U.S. Department of the Interior
BUREAU OF LAND MANAGEMENT

Sundry Print Report
06/03/2024

Well Name: TOP SPOT 12-13 FEDERAL COM

Type of Action: APD Change

Form C-102
Revised August 1, 2011
Submit one copy to appropriate District Office

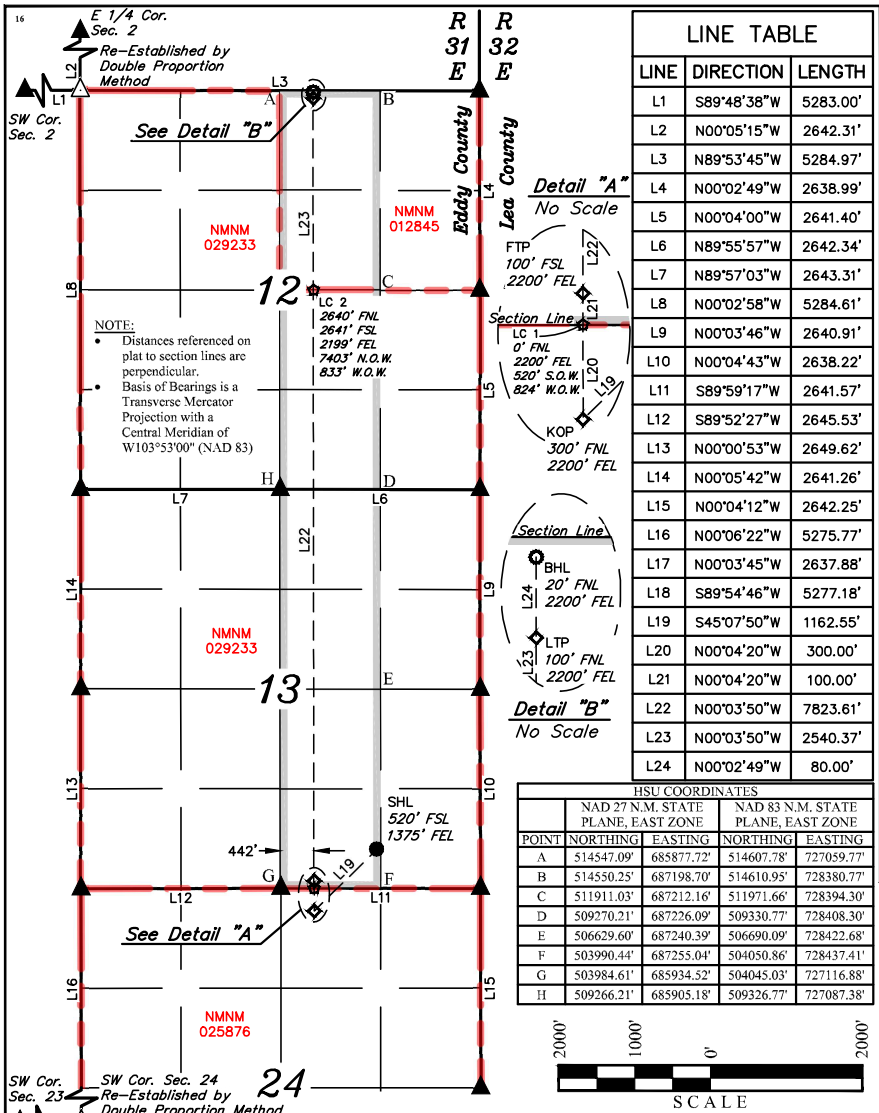
"SHL IS MOVING BY 30' TO THE SOUTH AND 345' TO THE EAST. THERE IS NO ADDITIONAL SURFACE DISTURBANCE RELATED TO THIS SUNDRY.
